A DESCRIPTION OF THE  
NUCLEAR DESIGN AND ANALYSIS PROGRAMS  
FOR BOILING WATER REACTORS

SUBJECT: ACCEPTANCE FOR REFERENCING OF LICENSING TOPICAL REPORT WCAP-10106  
"A DESCRIPTION OF THE NUCLEAR DESIGN AND ANALYSIS PROGRAMS FOR  
BOILING WATER REACTORS"

EVALUATION OF WESTINGHOUSE NUCLEAR DESIGN AND ANALYSIS  
PROGRAMS FOR BOILING WATER REACTORS-WCAP 10106 (TACS 48566)

QUESTIONS ON WESTINGHOUSE NUCLEAR DESIGN PROGRAMS  
FOR BOILING WATER REACTORS - WCAP 10106

FIGURE 2-4: PHOENIX Calculational Flow Design

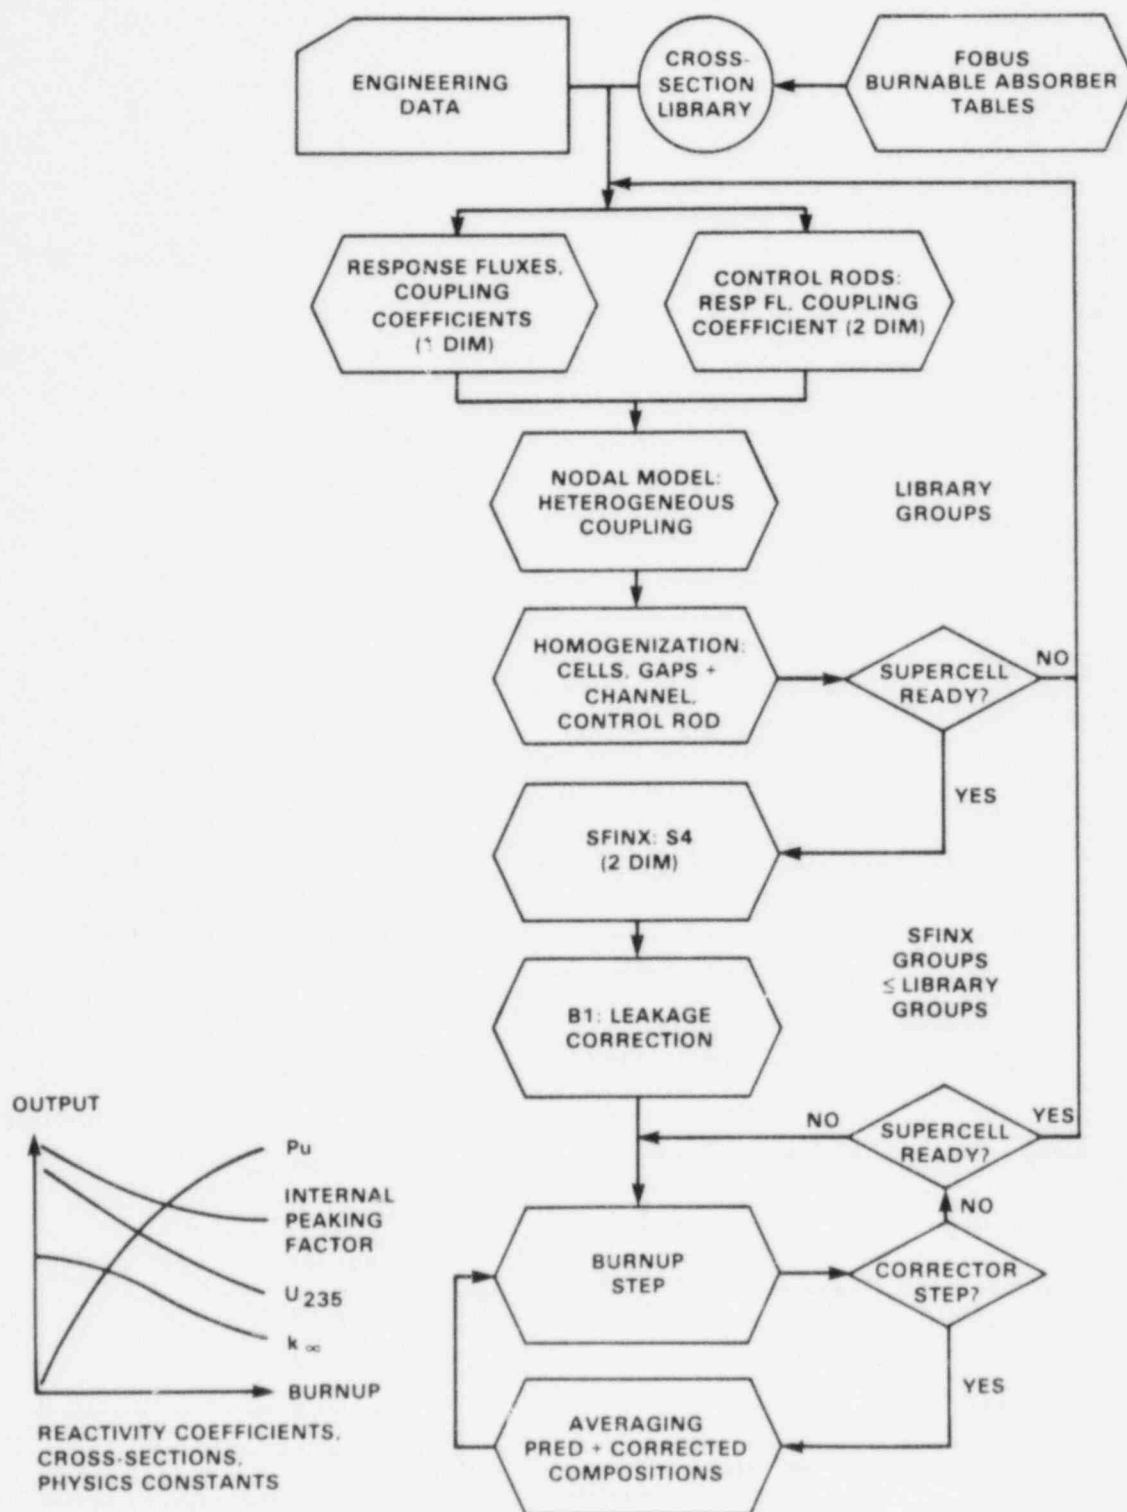
Figure 2-4 indicating that SFINX group  $\leq$  library groups appears incorrect since the text implies a maximum of 12 groups for SFINX calculations. Please clarify.

FIGURE 2-7: PHOENIX In-Core Detector Modeling

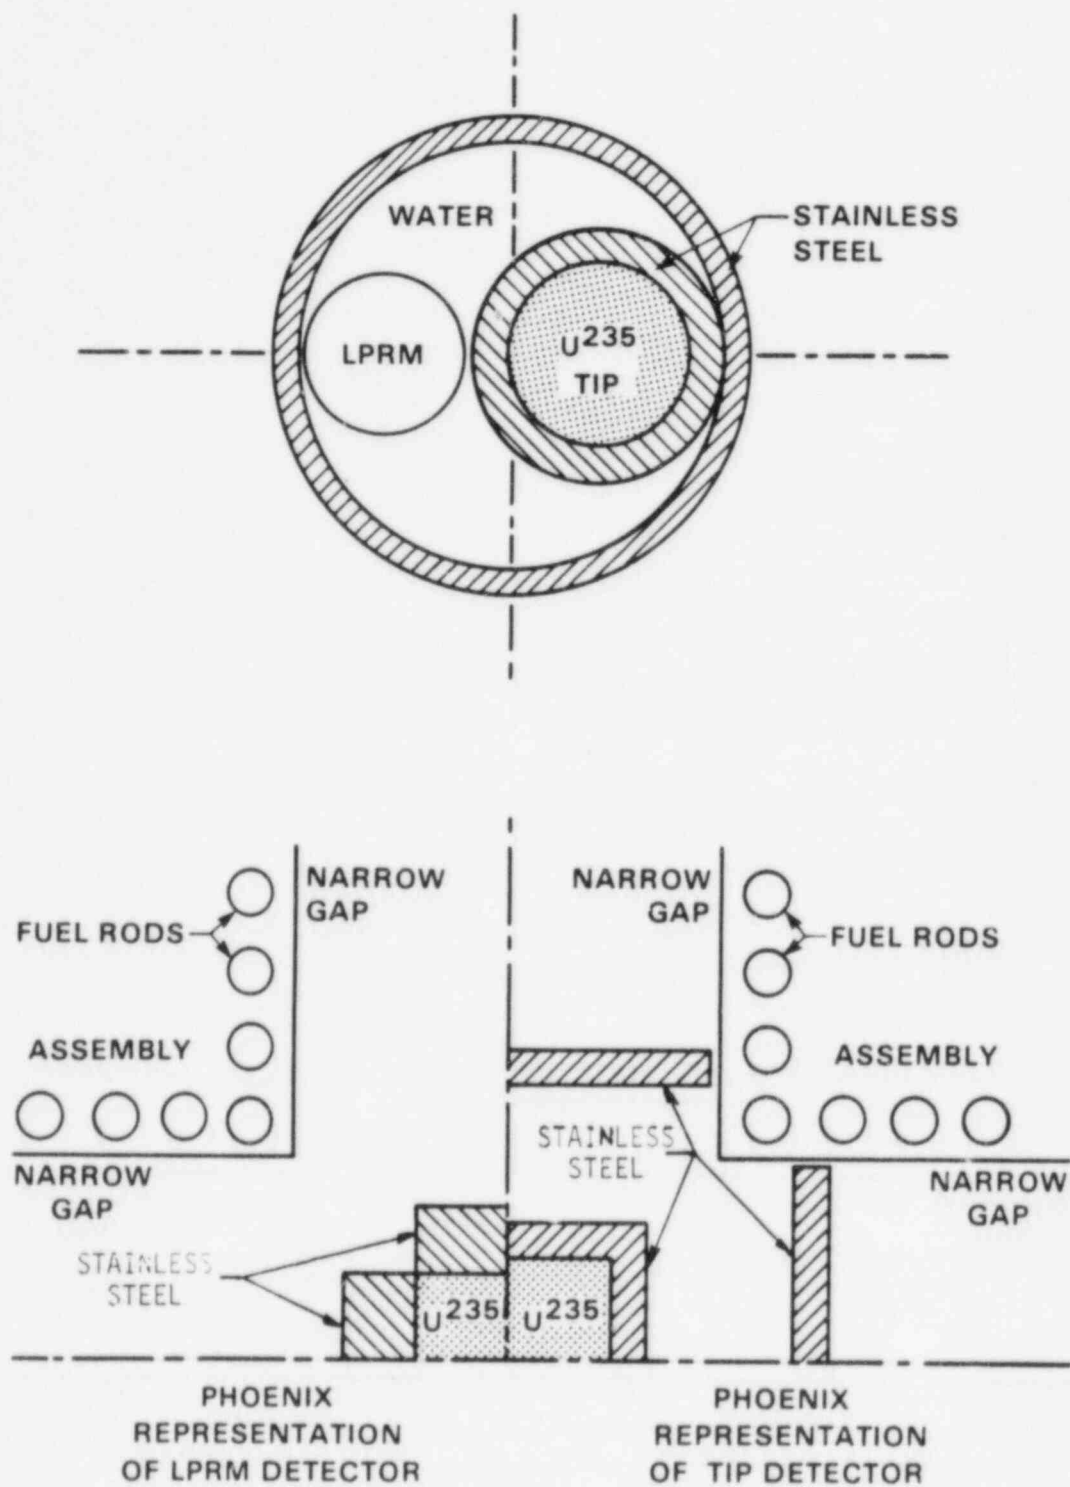
Justify the representations for LPRMs and TIPs as shown in Figure 2-7, particularly with regard to the tube surrounding both detectors. What void is used for the channel?

The PHOENIX two-dimensional physics lattice code is used to generate the detector relative signal as a function of exposure, void history and instantaneous void. This data is then input to the POLCA 3-D core simulator program in tabular form as a function of the above listed parameters. The detector model in PHOENIX is as shown in Figure 2-7 of the topical (WCAP-10106). The stainless steel cladding for the TIP detector, as well as the stainless steel clad of the instrumentation tube

through sub-factors that make up the detector correction term  $C_d$  in Equation (1) in the response to Question 19 in the PHOENIX section. The burnup void and instantaneous void fractions assumed in the channel are normally 0%, 25%, 50%, and 75% void. The position of the detector relative to the assembly in the PHOENIX model also matches the actual nominal position of the detector. Thus, the PHOENIX model preserves all important features of the detector in order to assure an accurate simulation.
